Third Party Request for Deviations from Systemwide Station Design Standards Policy

Purple Line Extension
Westwood/UCLA Station

Planning & Programming Committee

Design Deviations Requested by UCLA

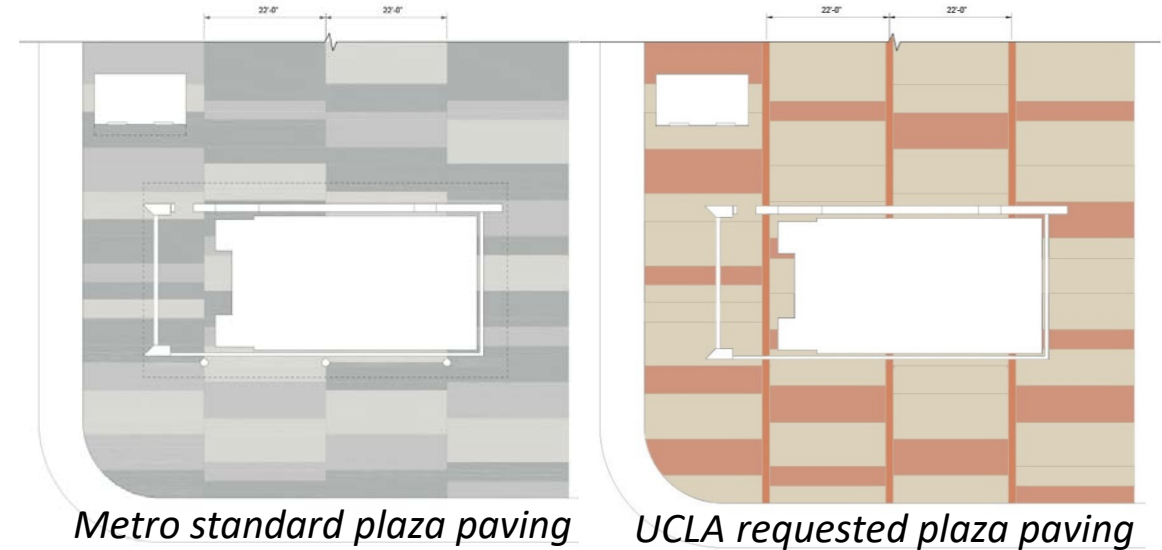
- Change Metro standard three-toned gray concrete plaza finish to beige and light red concrete.
- Change Metro station entrance portal canopy finish from standard silver-colored stainless steel to beige tinted stainless steel.
